DEEP Fisheries Consultation Form

Name of Site: Bridge No. 131017 - Marion Avenue over Unnamed Brook
Address of Site or Location Description: Bridge adjacent to 1210 Marion Ave
City/Town: Southington State: CT Zip Code: 06489
Parcel Location/Tax Assessor's Reference: Map Block Lot
Name of Stream or Waterbody: Unnamed brook contributing to Humiston/Judd Brook

DEEP FISHERIES DIVISION DETERMINATION

MARION AVENUE BRIDGE REPLACEMENT

PMT-02

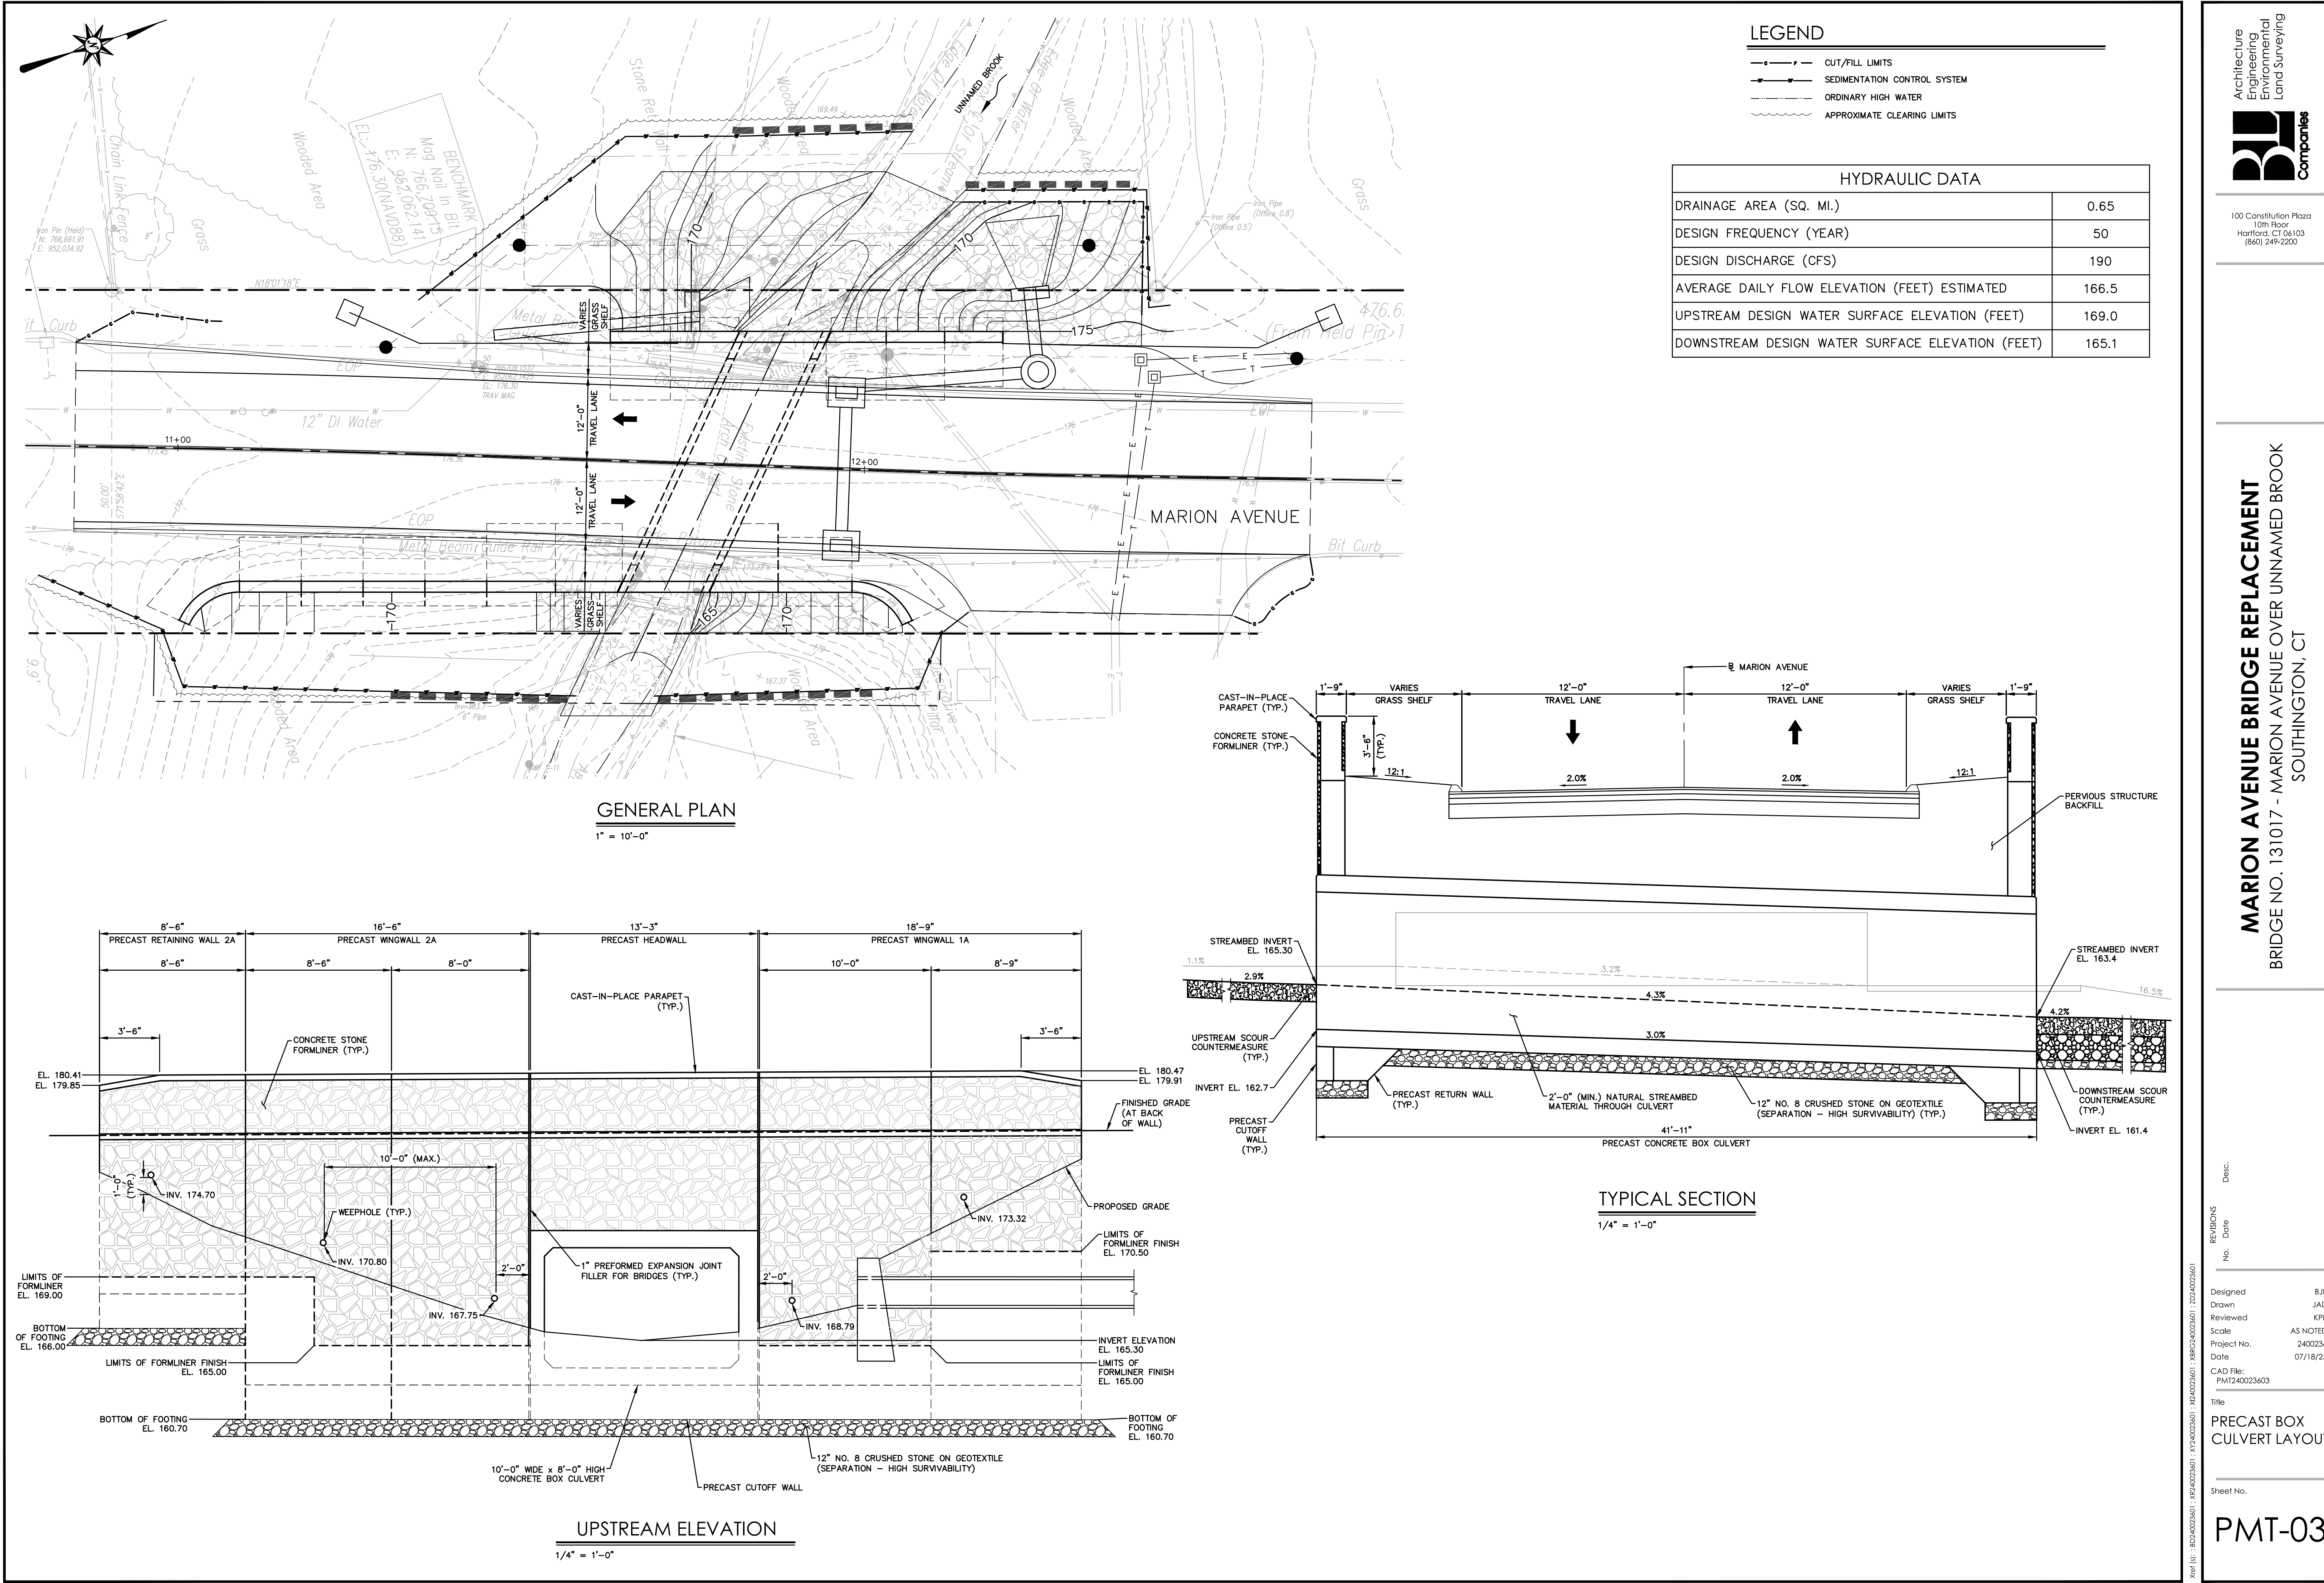
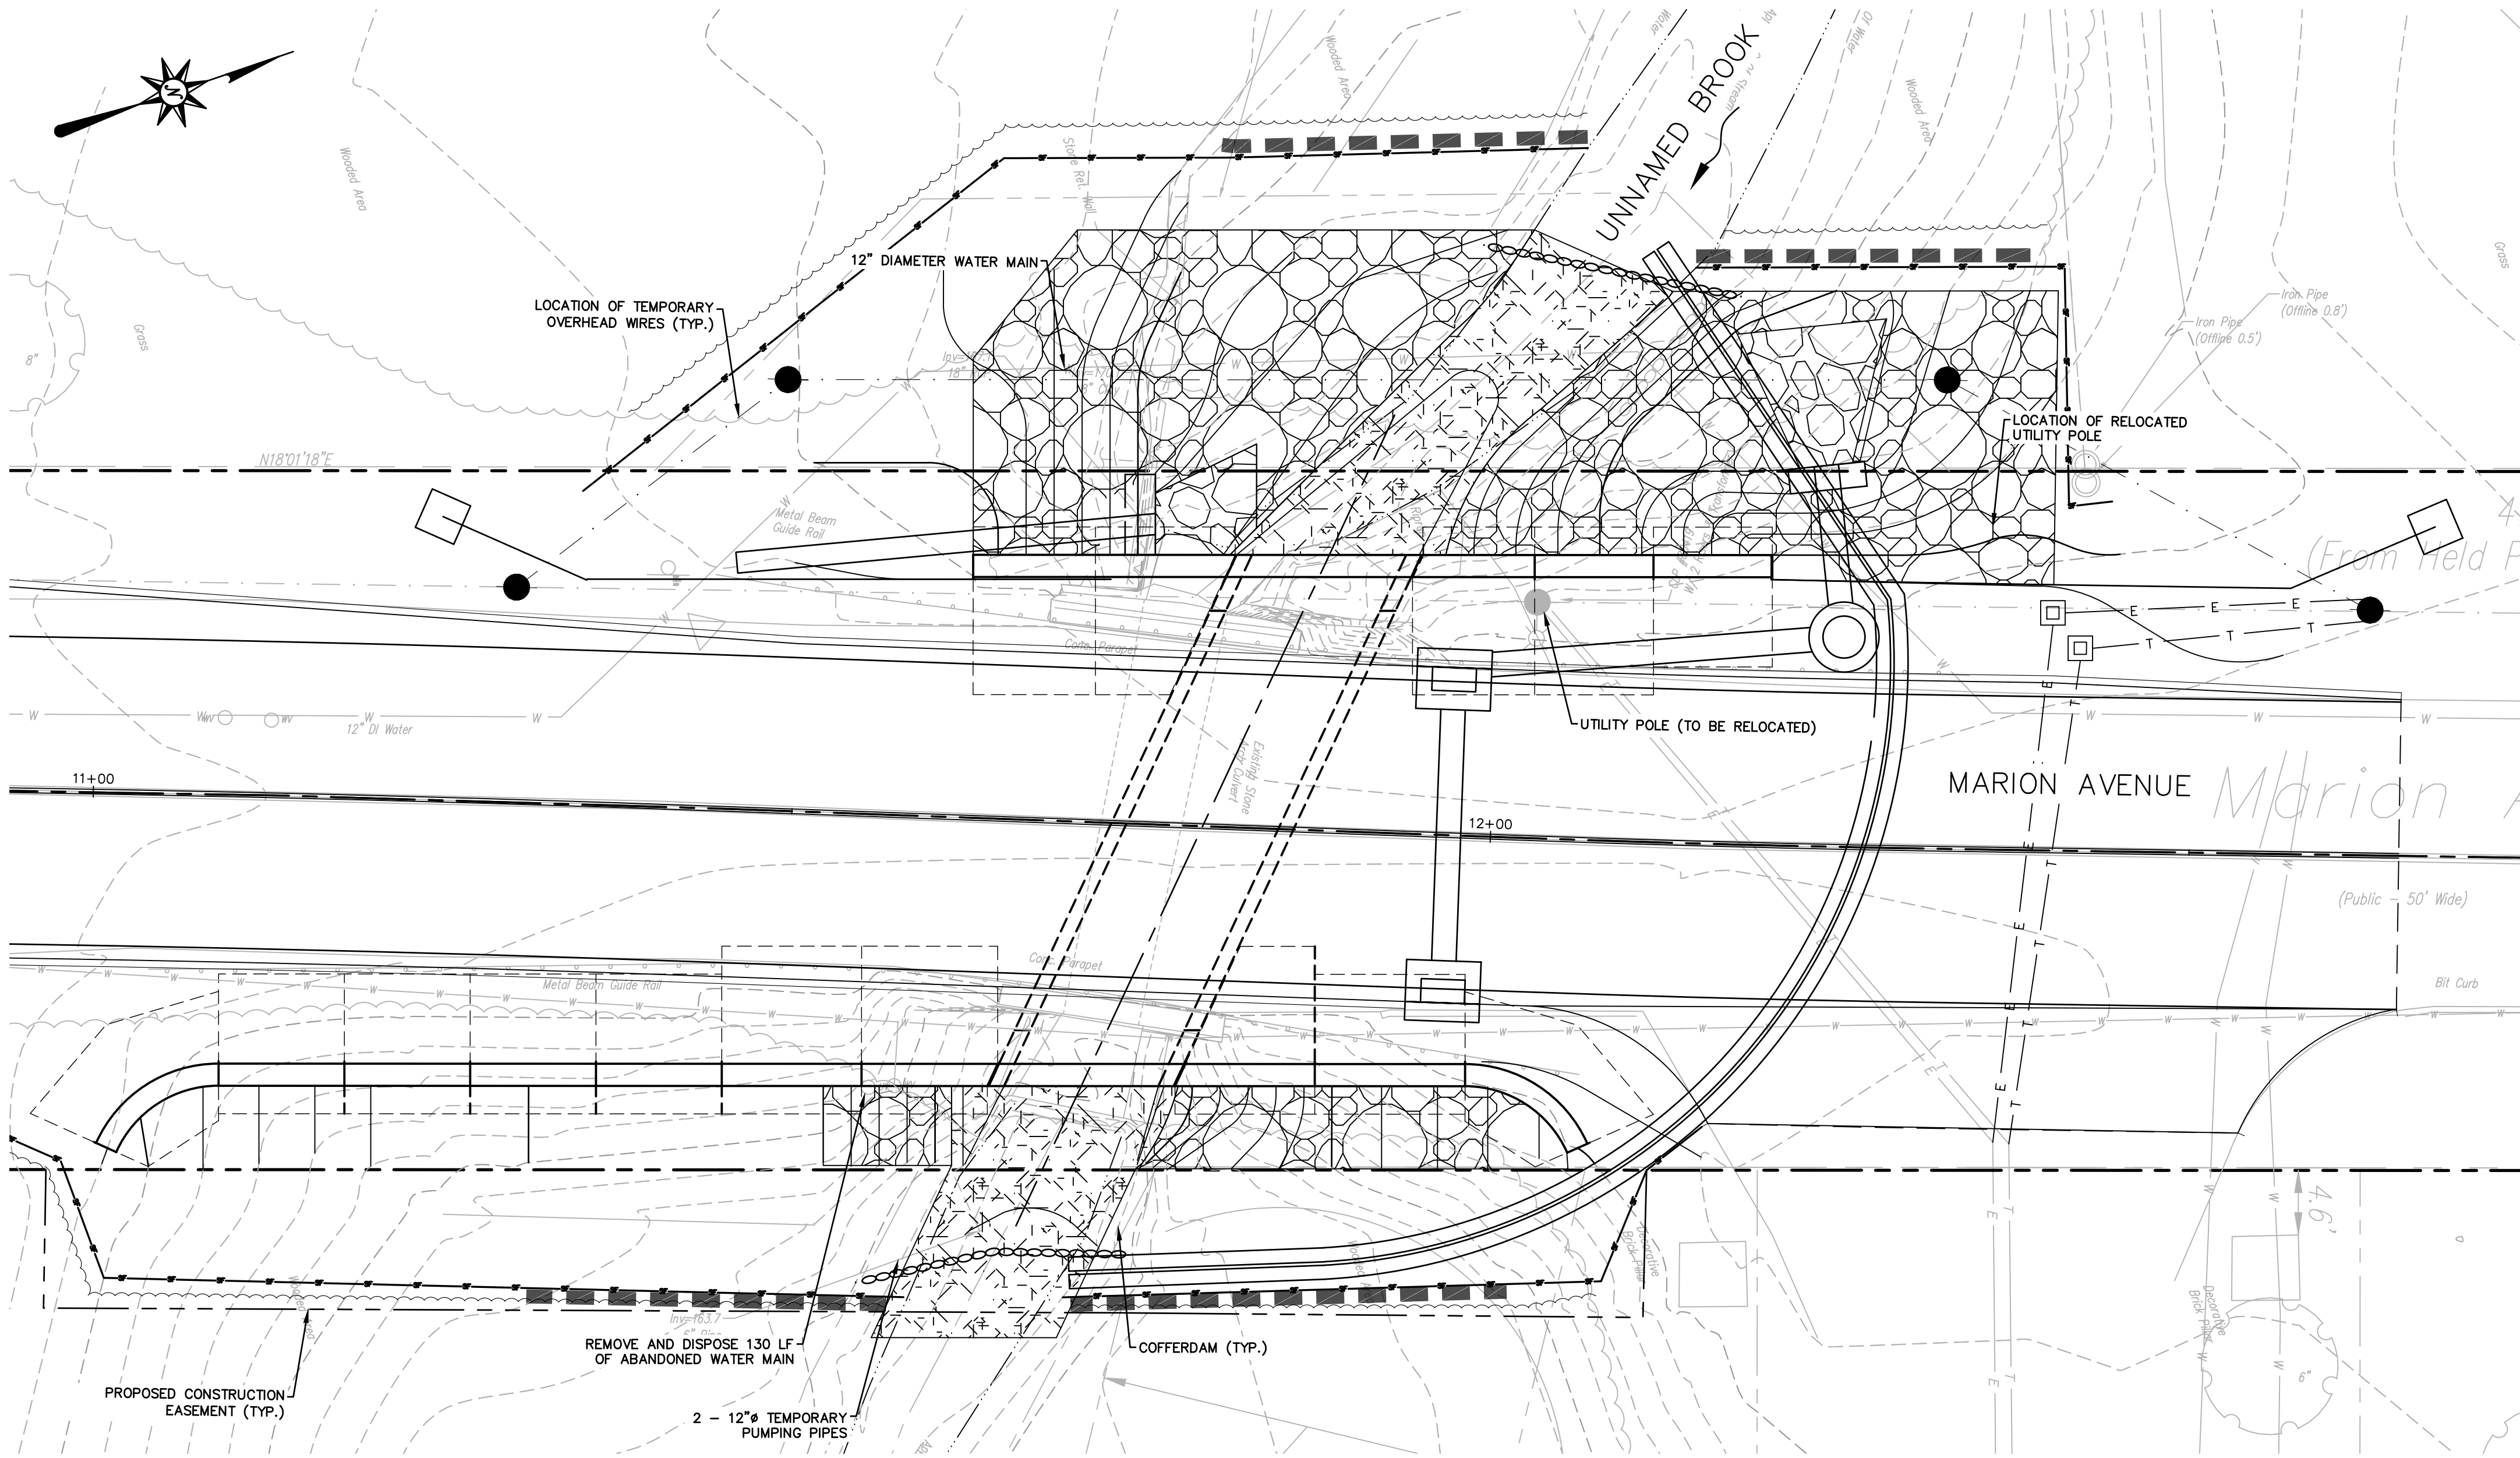
1. Unconfined in-water work is only allowed in June, July, August, and September.
2. Riprap placed within OHW should have fines (gravel/sand) washed into interstitial spaces to prevent subsurface flows and be top dressed with 12" of natural streambed material.
3. All other comments incorporated into plans.
